**NEW YORK STATE THRUWAY AUTHORITY
DEPARTMENT OF ENGINEERING**

**AMENDMENT NO. 2
TO**

**CONTRACT TANY 26-23B
D215110
SUPERSTRUCTURE REPLACEMENT OF THE
GARDEN STATE PARKWAY CONNECTOR BRIDGE
OVER THE THRUWAY (I-87/I-287) AT MP 23.53
IN THE NEW YORK DIVISION
OF THE NEW YORK STATE THRUWAY
IN ROCKLAND COUNTY**

**IN THE LETTING OF
OCTOBER 7, 2026**

DRAWING NUMBER:
ST-23

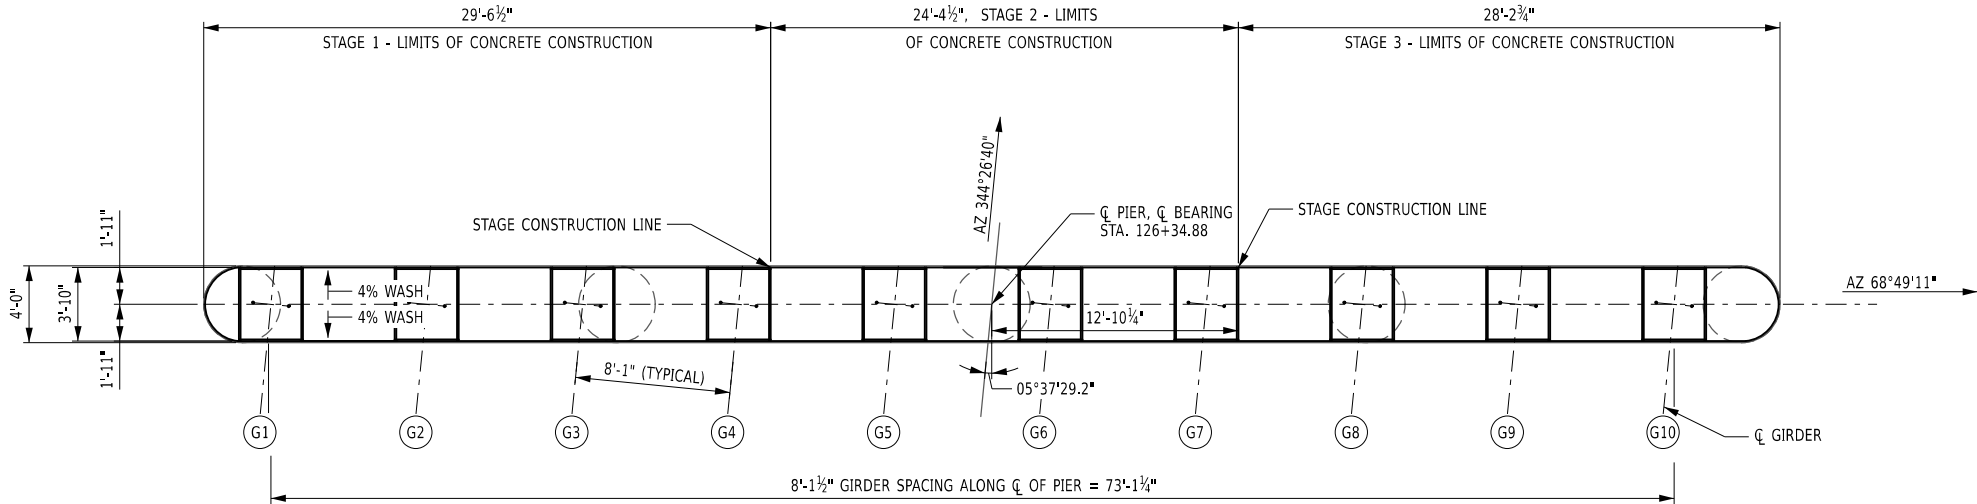
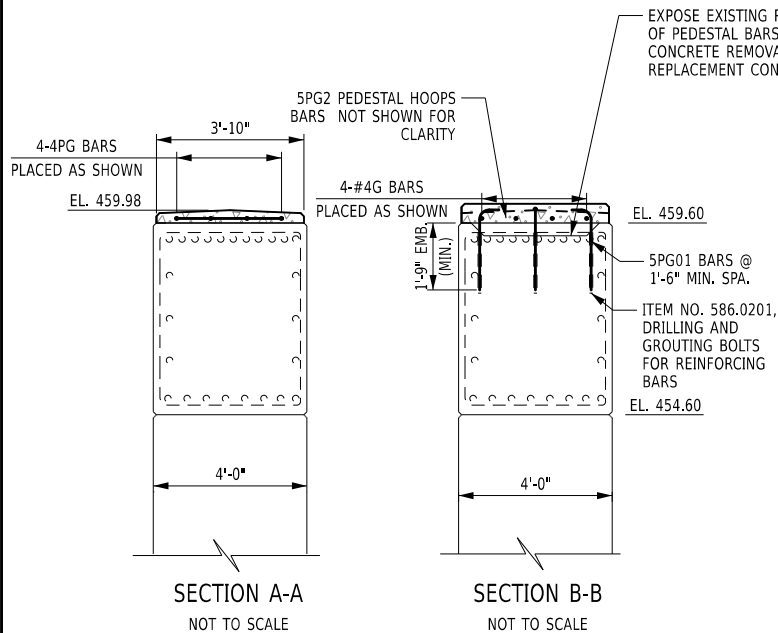
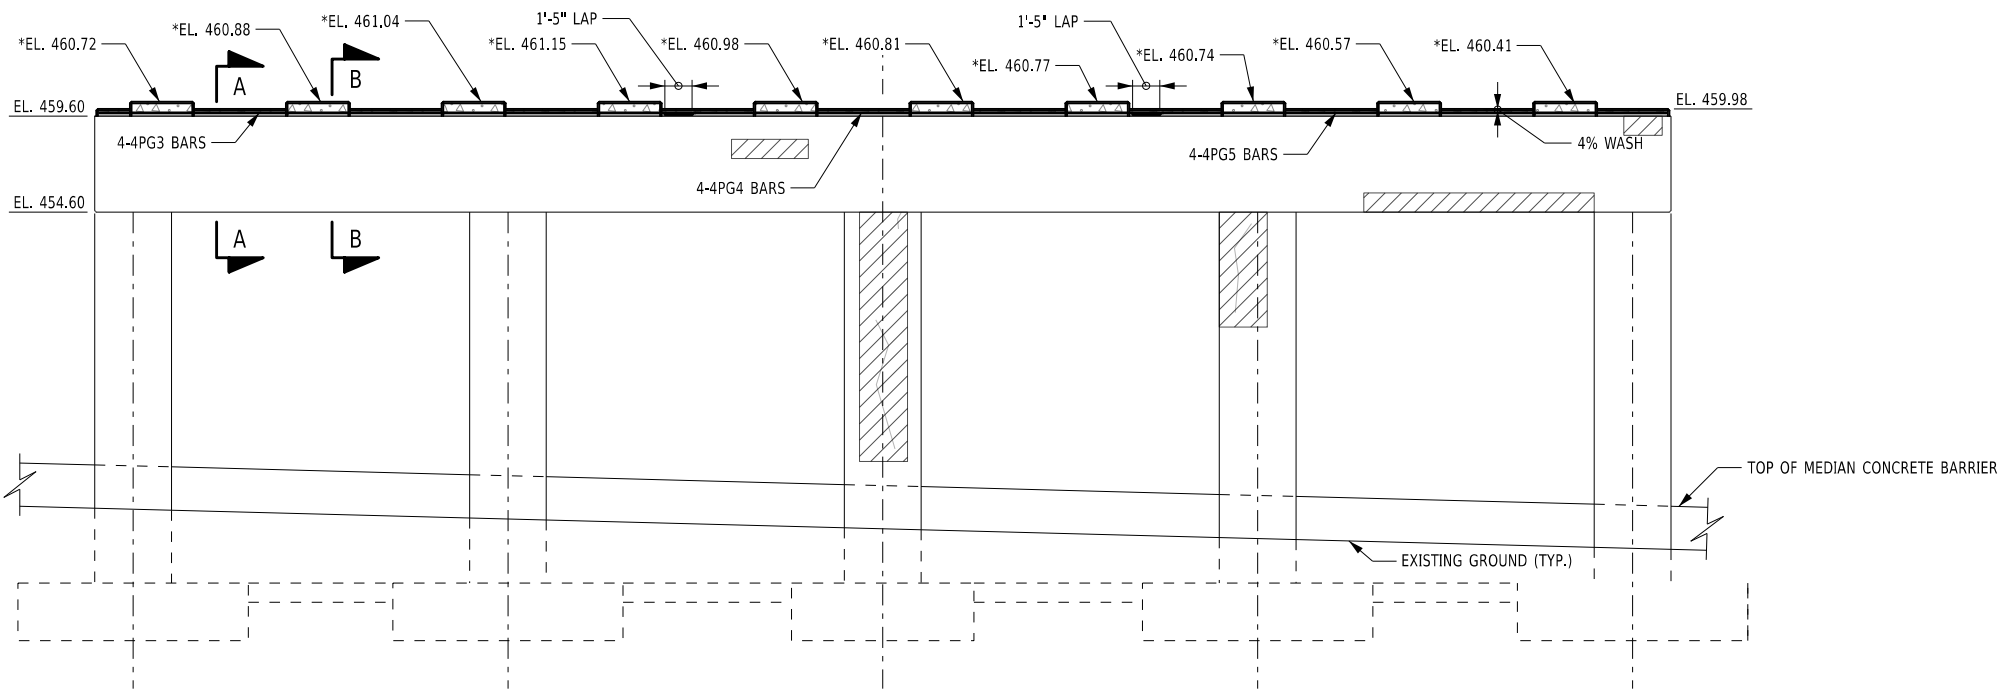
11. **DELETE** Drawing Number ST-23, Sheet 73 of 118, and **SUBSTITUTE** with the attached Drawing Number ST-23, Sheet 73A2 of 118. The estimated quantities for Item 555.0021 have been updated in the Concrete Table. In Section B-B, a note was added to state that the quantity of concrete that will need to be removed and replaced to expose rebar will be paid for under Item 580.01 and Item 555.0021, respectively.

TITLE OF PROJECT SUPERSTRUCTURE REPLACEMENT GSP CONNECTOR OVER NYS THRUWAY	CONTRACT NUMBER: TANY 26-23B
LOCATION OF PROJECT BIN 5514049 (MP 23.53)	DATE: JULY 2026
TITLE OF DRAWING PIER 2 REPAIR PLAN & ELEVATION (1 OF 2)	DRAWING NUMBER: ST-24

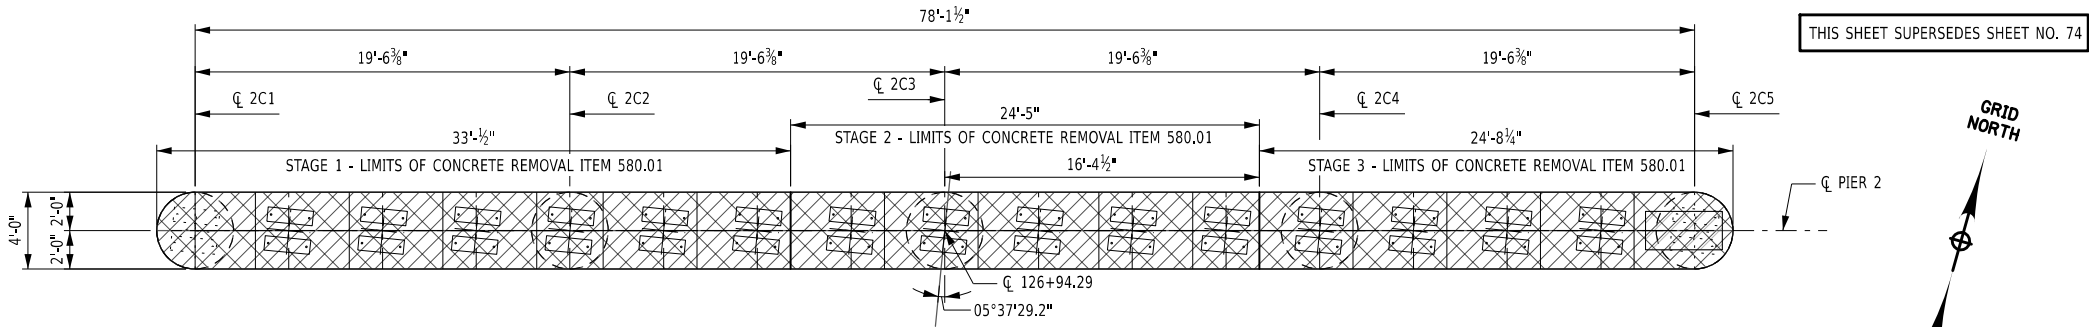
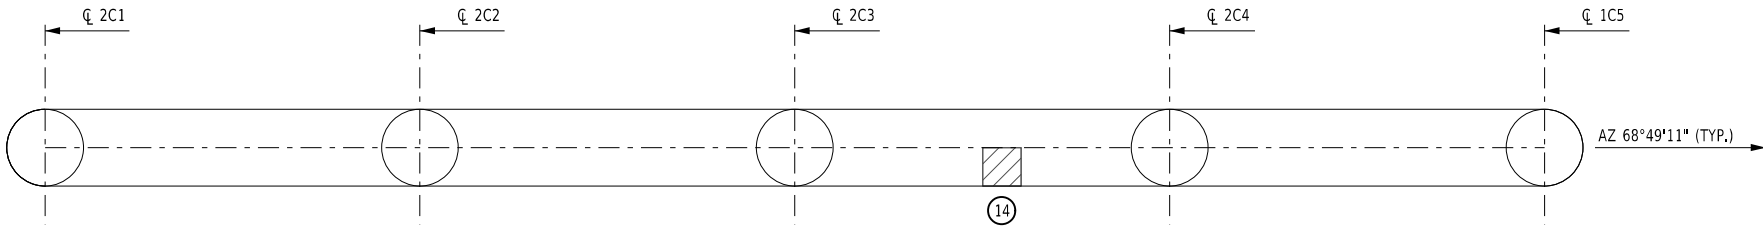
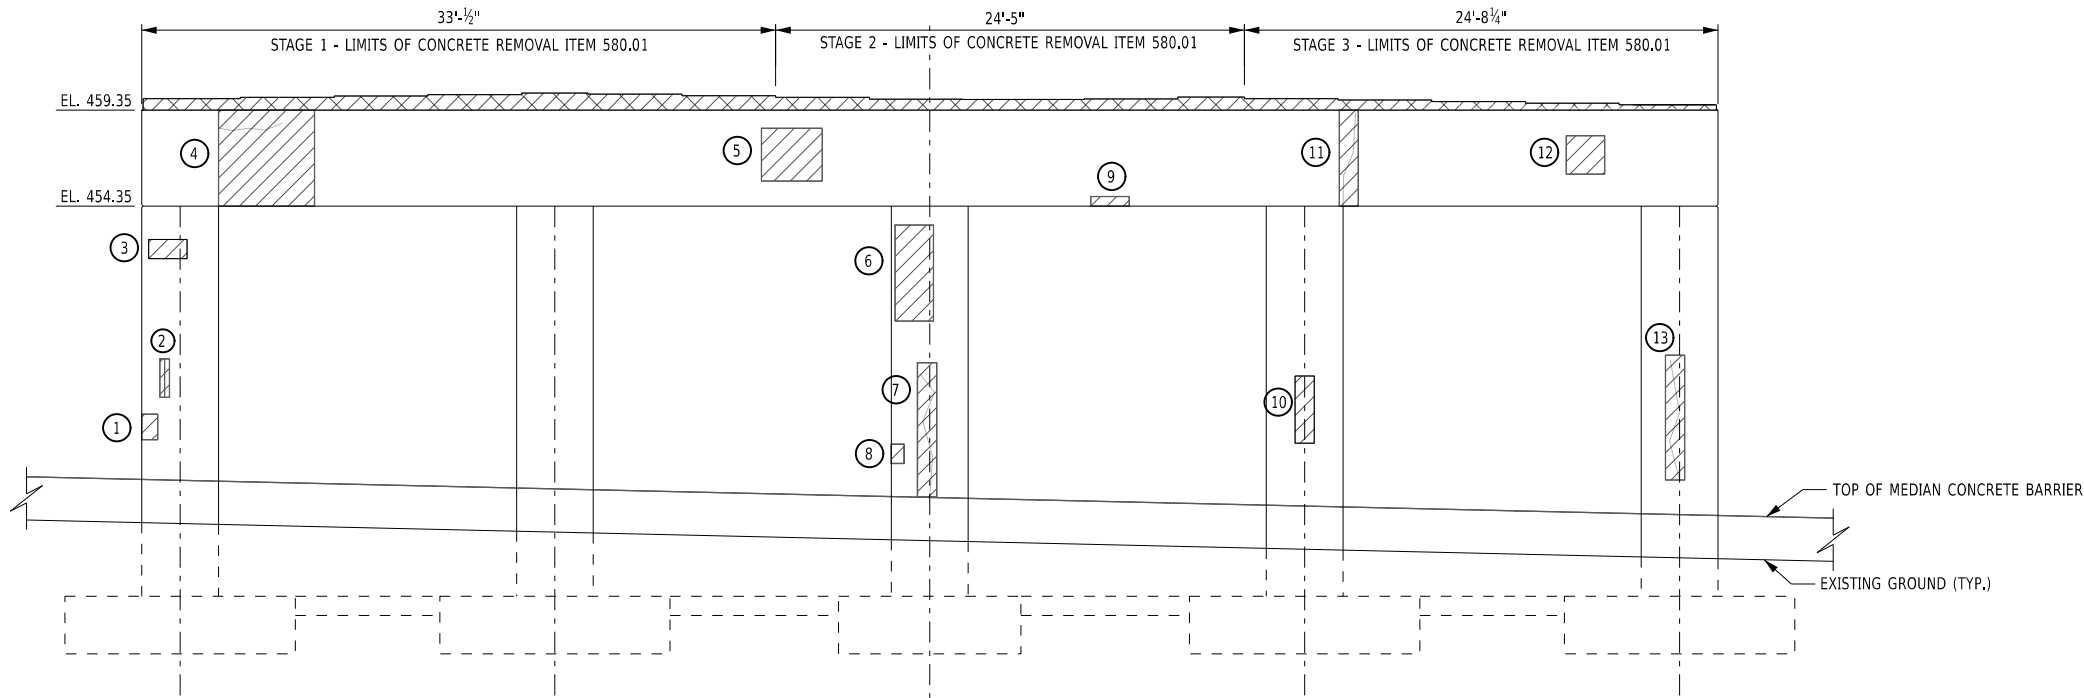
12. **DELETE** Drawing Number ST-24, Sheet 74 of 118, and **SUBSTITUTE** with the attached Drawing Number ST-24, Sheet 74A2 of 118. The estimated quantities for Item 580.01 have been updated in the Concrete Removal Table.

TITLE OF PROJECT SUPERSTRUCTURE REPLACEMENT GSP CONNECTOR OVER NYS THRUWAY	CONTRACT NUMBER: TANY 26-23B
LOCATION OF PROJECT BIN 5514049 (MP 23.53)	DATE: JULY 2026
TITLE OF DRAWING PIER 3 REINFORCEMENT DETAILS	DRAWING NUMBER: ST-29

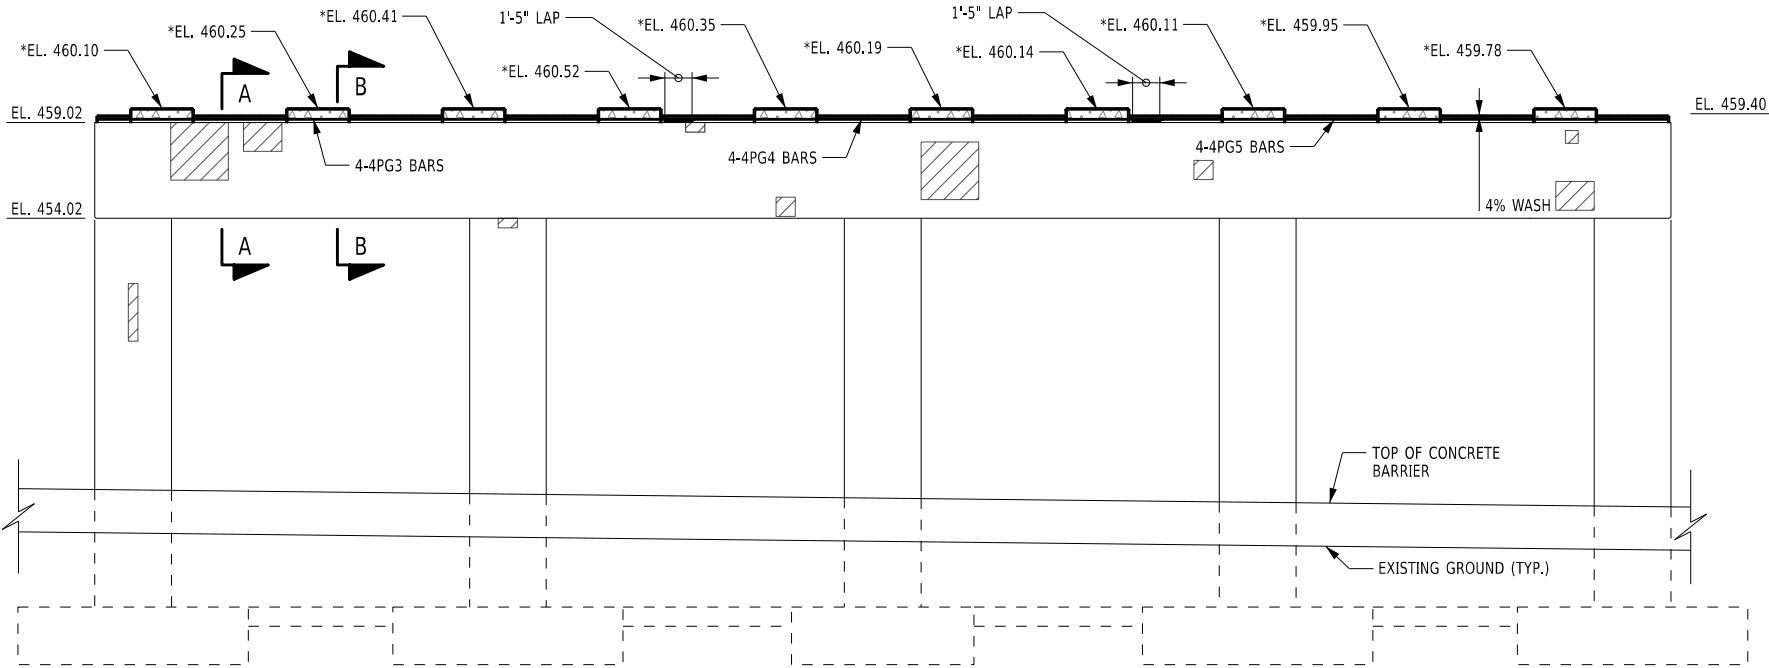
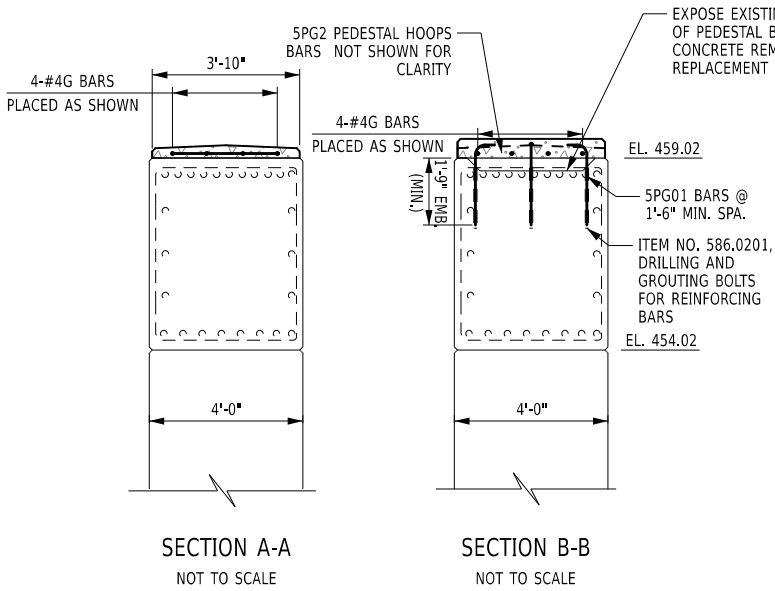
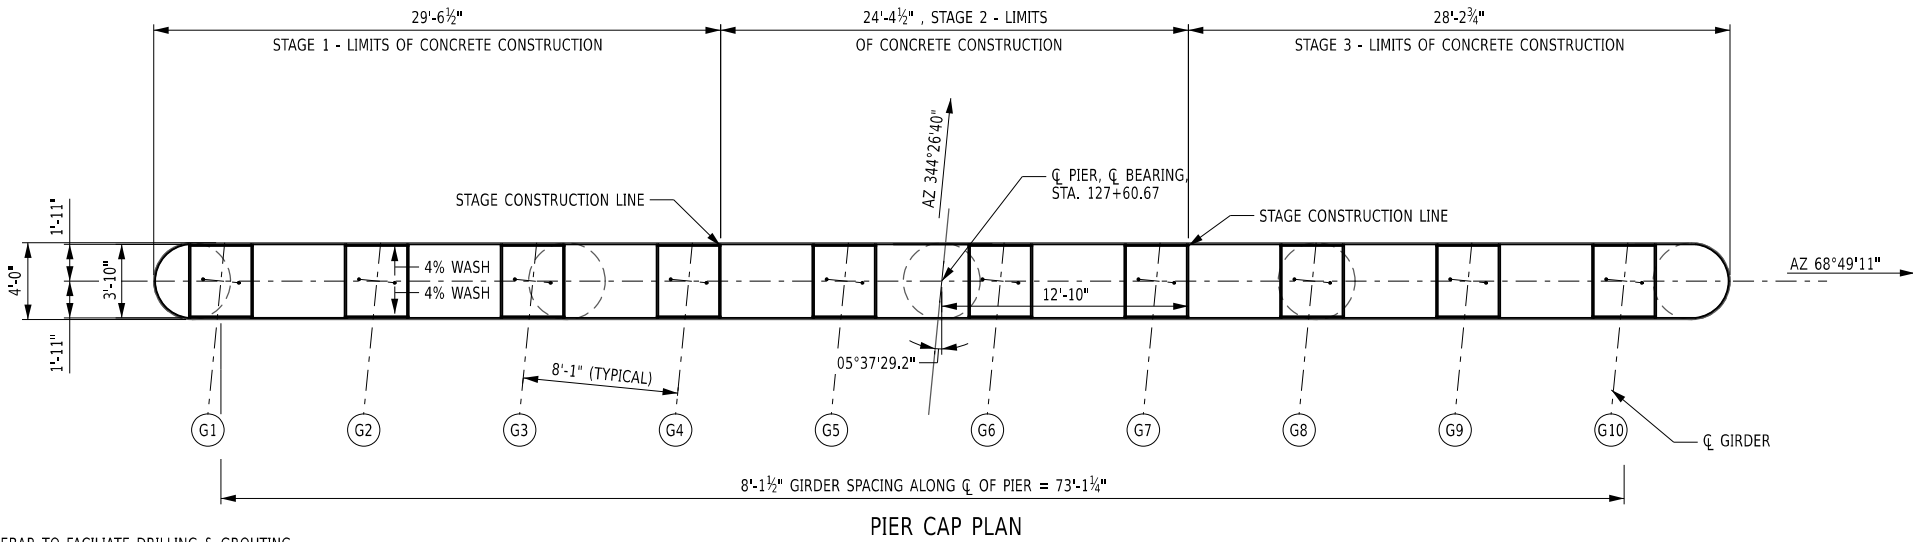
15. **DELETE** Drawing Number ST-29, Sheet 79 of 118, and **SUBSTITUTE** with the attached Drawing Number ST-29, Sheet 79A2 of 118. The estimated quantities for Item 555.0021 have been updated in the Concrete Table. In Section B-B, a note was added to state that the quantity of concrete that will need to be removed and replaced to expose rebar will be paid for under Item 580.01 and Item 555.0021, respectively.
